Amendments to the Drawings:

REMARKS/ARGUMENTS

Fig. 5A

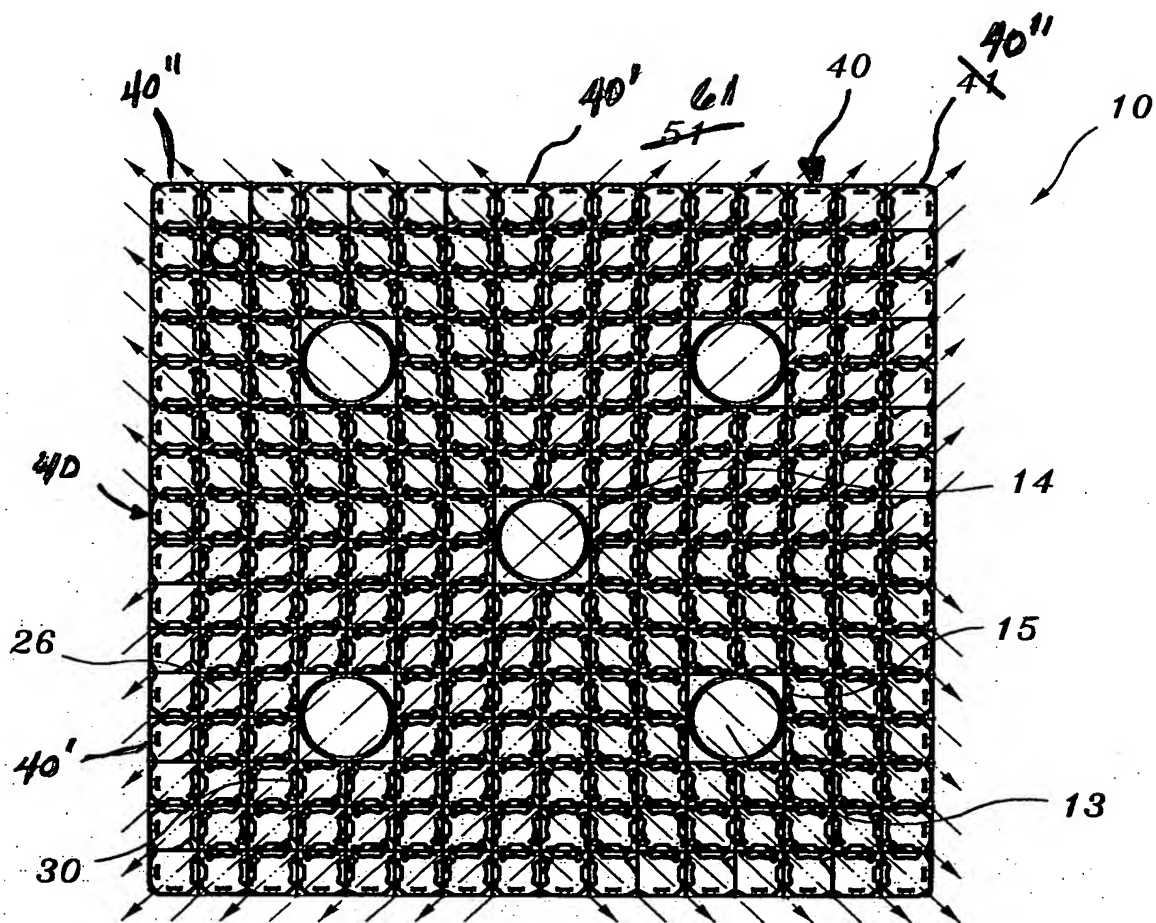
The attached sheets of drawings include changes to Figure 5A, 7A, and 7B. In these Figures, reference numerals have been amended.

Fig. 7A

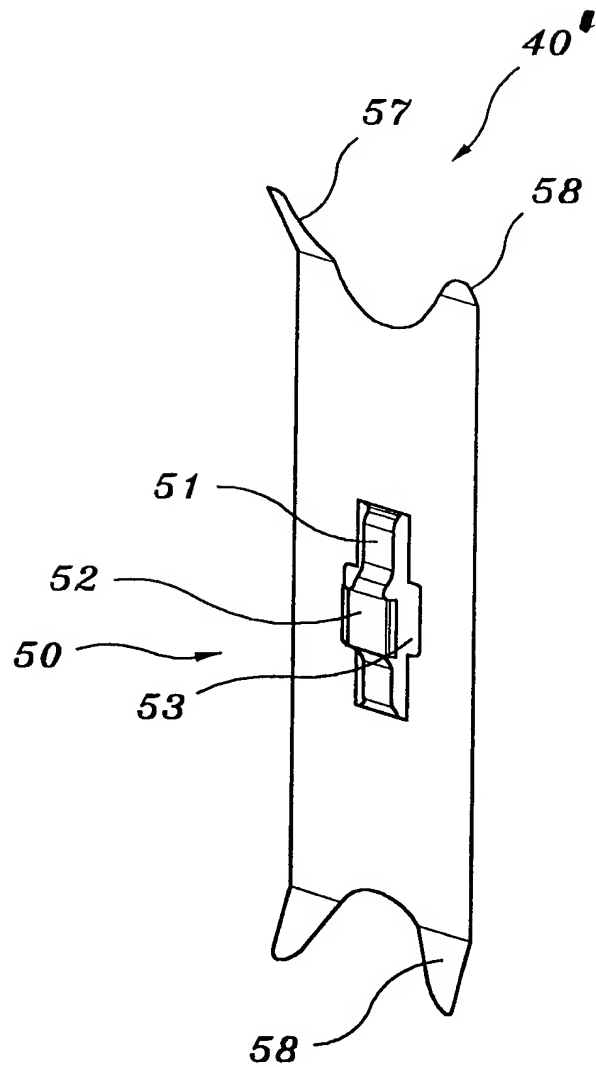
The examiner in his office action dated July 8, 2004 rejected previously submitted claims 1-6 under 35 U.S.C. 112, second paragraph as being indefinite. Applicant by the instant amendment has amended the specification and has submitted proposed drawing corrections with regard to reference numerals only and Applicants believe that the amendments to the specification and drawings obviates the examiner's rejection under 35 U.S.C. 112, second paragraph. The specification and drawings clearly indicate that the outer perimeter of the spacer grid 10 is formed by a plurality of perimeter strips 40 each of which comprises a plurality of unit intermediate strips 40' and two unit corner strips 40". Additional reference numerals have been added to Figure 5A so as to be consistent with the foregoing. Stated in another way, each perimeter strip 40 comprises a plurality of intermediate sections 40' between corner sections 40". Each of the intermediate units 40' include a spring element 50 as shown in Figure 7A while each corner unit 40" has a spring element 50 as shown in Figure 7B. Thus, as
